# Service Bulletin

**Issue 108**

**December 16, 1998**

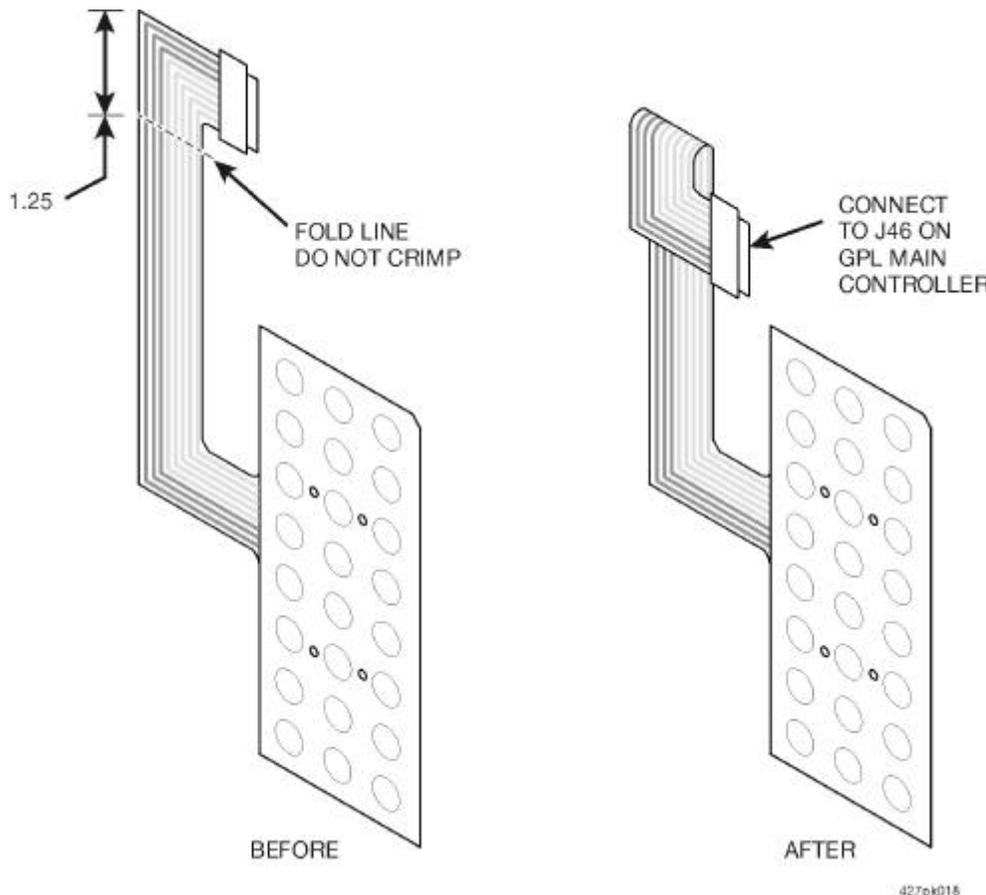
It is possible on a 427 Food King to plug the membrane switch assembly (P/N 9984625) onto the controller PCB (J46) in a reversed position. In other words, the blue connector can be plugged in either direction. The symptom encountered is the selection buttons will do nothing when pressed or both the "exact change" and "selection price" LED's will light up.

The proper way for the plug to be connected is with the connector end of the membrane rolled over. (See diagram below). To eliminate the possibility of an incorrect connection a new membrane switch assembly (P/N 9984621) is being made available with the connector end pre-rolled and held in place by an adhesive strip. Please note the original part works fine when connected properly. There is no need to replace the existing part.
